Bulletin Number - BP2A - 01

Project	Steamboat I	Base Village Re	devel	opment		Date 05/26	/2021	
Project Location	Steamboat,	Colorado				Architect's Pro	ject Number 03.7	835.000
Owner/Client	Alterra Mour	ntain Company	/ Eas	t West Partners	S	File 6BL T	his is page 1 of	
То	Saunders Co	onstruction Inc.				Attention B	ryan Sculthorpe	
Address	86 Invernes	s Place North						
City	Englewood					State CO	Zip 80112 Code	
Delivered via:	П	Messenger	П	Hand carried	П	Facsimile		
Denvered via:		Express		Pick-up		E-mail Address		
		Mail		UPS		Website Address	BIM360	
This Bulletin Convey	s to Contractor (Check one of the fo	ollowing	g five choices.):				
Architect's Author		or Changes to the Work as des	cribed	below.				
		mental Instruction				, ,	ntal Instructions form	•)
Architect's Confir This confirms Archi Note: The above the is/are issued in acco	tect's verbal instr ree choices are ea	ructions to (individu ach subject to the fo	al's nar ollowing	me) on (date g terms: The change	e), a: e(s), clarific	s described below. ation(s) and/or confir	mation(s) described b	RCRBI

General: This bulletin addresses clarifications to Gold Walk's door schedules, door hardware, and room numbering for pe

DEMOLITION SECTIONS - BUILDING B

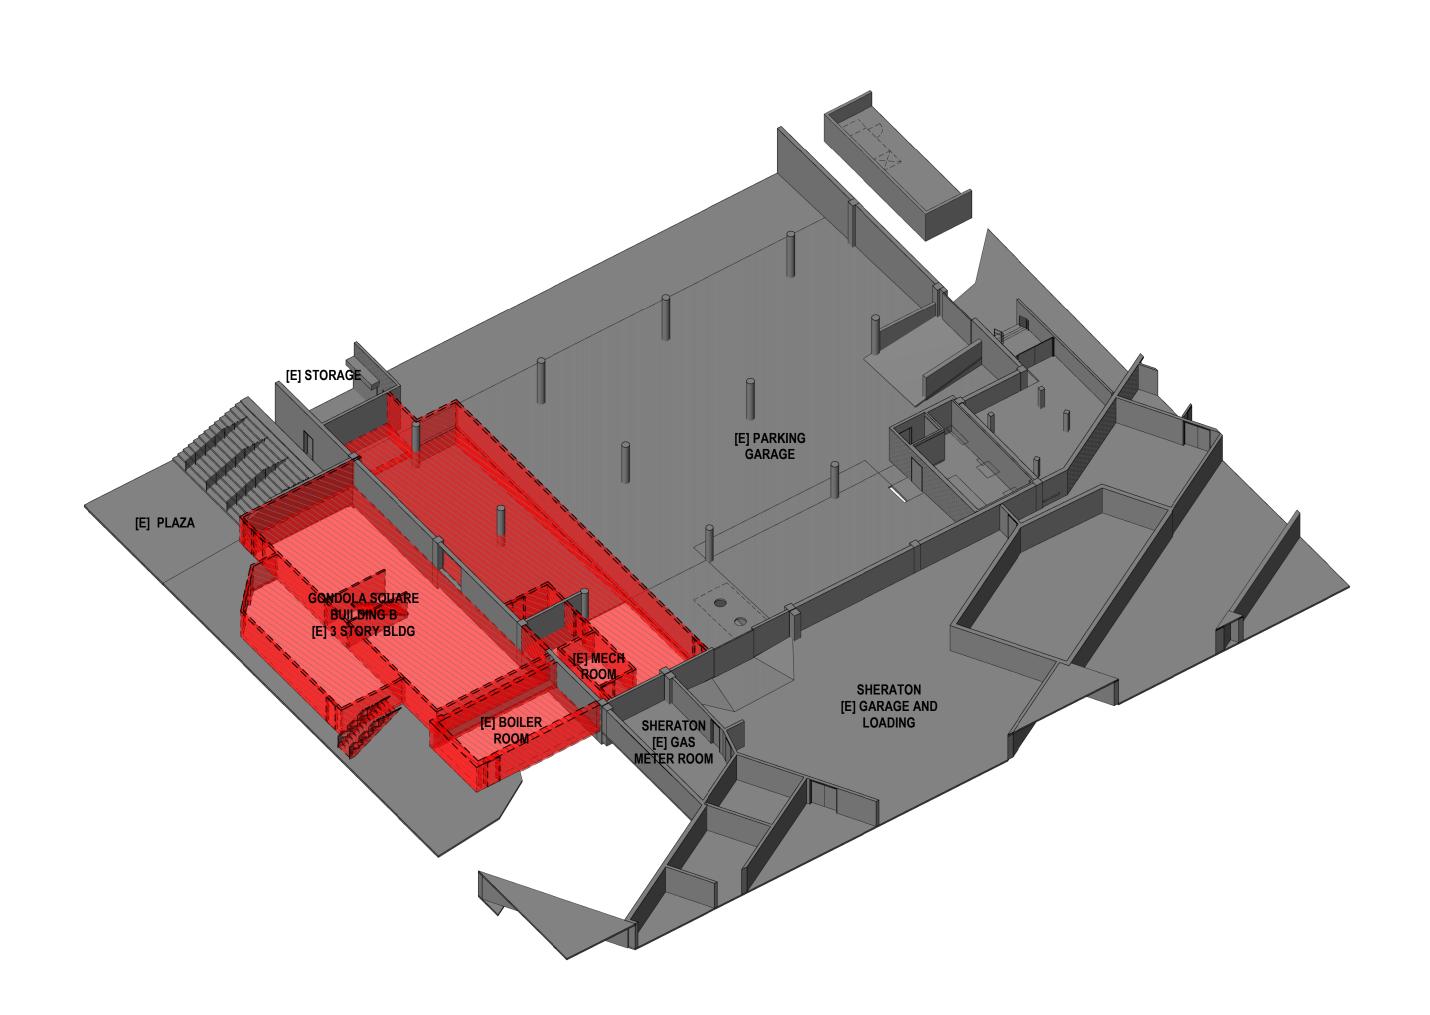
- c. Sheet notes Added notes #62 and 64-67
- 10. B-D3.101 DEMOLITION SECTIONS BUILDING B EW
 - a. 01 DEMOLITION SECION EW 3
 - i. Added topping slab removal

- ii. Added CMU wall removal
 - iii. Clarified existing conditions
 - iv. Added Sheraton scope
 - b. Added Demolition Details 02 & 03
 - c. Sheet Notes Added notes #22, 62, 63, 68, 71, and 75-77

B-D4.100

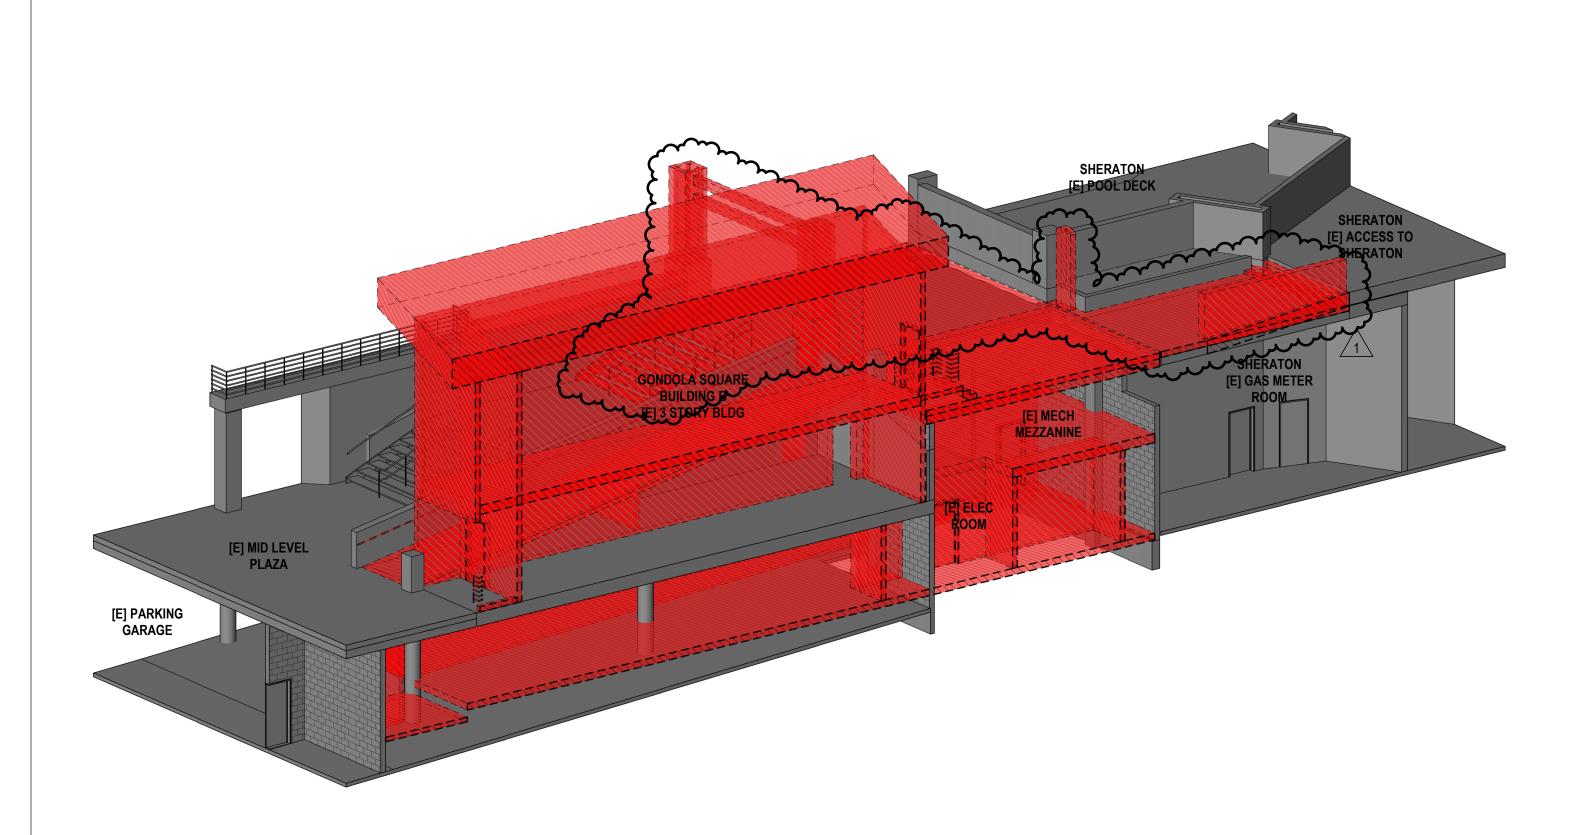
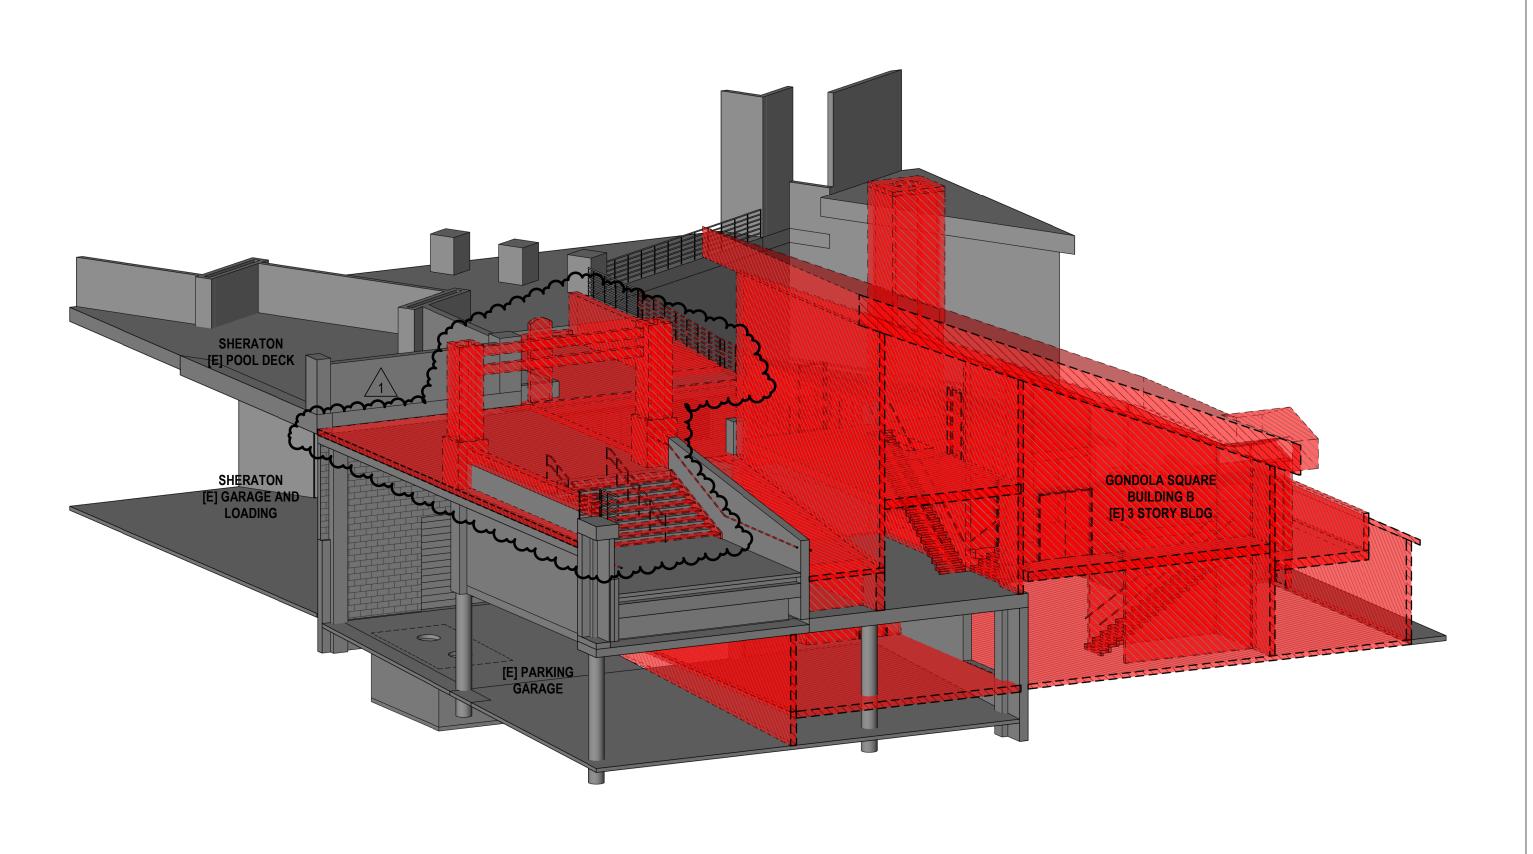
- ii. Stairs shown as removed
 - c. Sheet Notes Added notes #62, 64, and 70-72
- 12. B-D4.100 DEMOLITION AXONOMETRIC BUILDING B
 - a. Demo Axon Revised indicated scope

- b. Demo Section Axon A Revised indicated scope
 - c. Demo Section Axon B Revised indicated scope
 - d. Demo Section Axon C Revised indicated scope
- 13. B-D4.101 DEMOLITION AXONOMETRIC BUILDING B
